RE: Request to Approve Change Order #19  
Football Stadium Project

# Change Order Request 19 - PCO #45 - RFP 07 - Rooftop Power

# REQUEST FOR PROPOSAL

PROJECT:	HIGH SCHOOL FOOTBALL STADIUMS BCHS, NBHS and BEHS Bullitt County, Kentucky	REQUEST FOR PROPOSAL NO.:	 07
OWNER:	Bullitt County Public Schools 1040 Highway 44 East Shepherdsville, KY 40165	DATE:	18-Aug-2023
TO CONTRACTOR:	Calhoun Construction Services, Inc. 7707 National Turnpike Louisville, KY 40218	ARCHITECT:	Studio Kremer Architects 1231 S Shelby Street Louisville, KY 40203
		ARCHITECT'S PROJECT NO.:	2022-57 BG# 23-157

SHEET NUMBER  
**PB-1b**

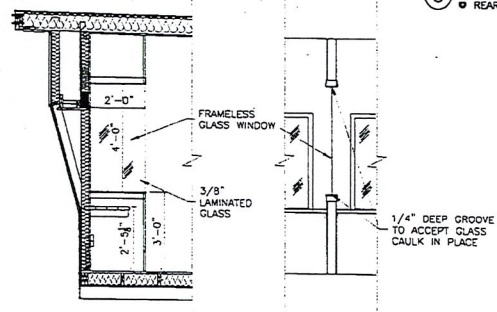
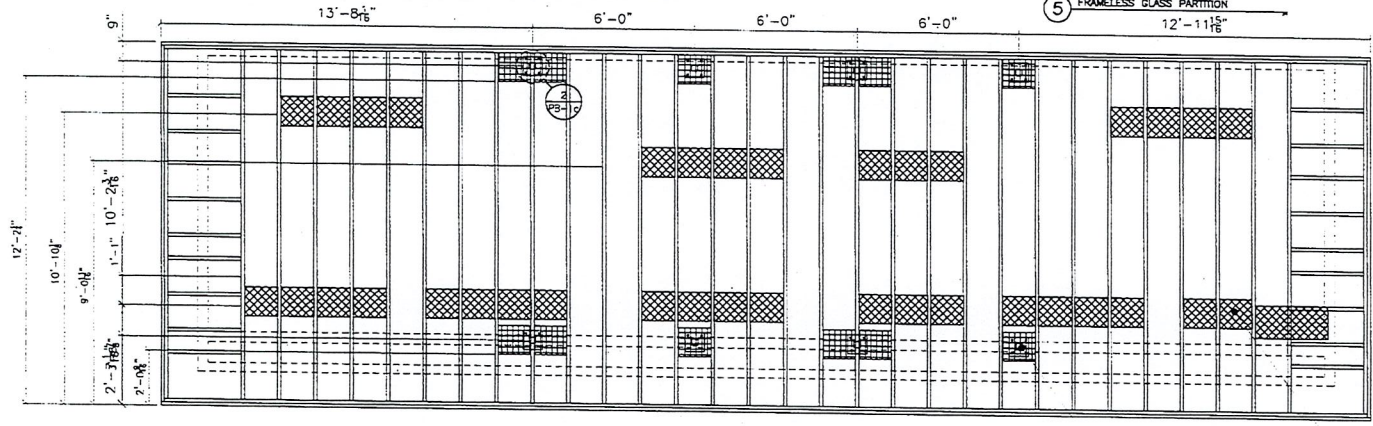
- Item 1:** -Refer to Dant Clayton PB-1b drawing
- o Refer to detail markup for scope of work clarified on PB-3.
- Item 2:** -Refer to Dant Clayton PB-3 drawing
- o Refer to high-lighted locations of roof power and clarification of legend Symbol and Description for additional scope of work to extend existing power to EC provided backbox and receptacle.

**PB-3**

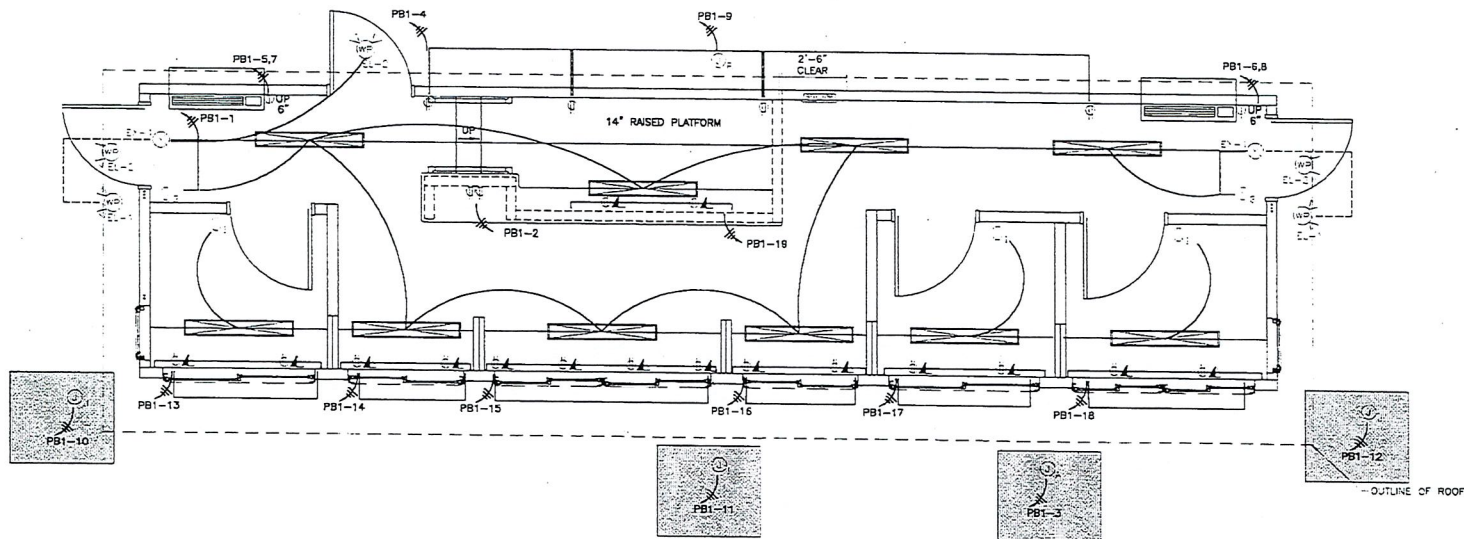
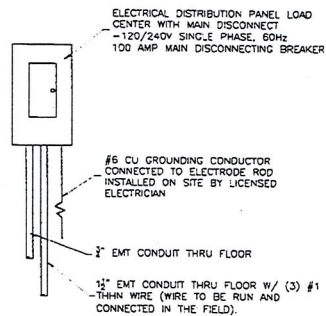
EC TO INTERCEPT AND EXTEND ROOF BACKBOX AND CIRCUIT AND PROVIDE NEW 3/4\"/>

WEATHER-RESISTANT RECEPTACLES IN WEATHERPROOF ENCLOSURES TO BE INSTALLED ON GUARD RAILS BY ECI
	ZONELINE #AZ261-H0RD 3.5 KW ELECTRIC WALL MOUNT UNIT WITH INTEGRAL THERMOSTAT HEAT PUMP UNIT 5.400 BTU COOL 6.300 BTU HEAT
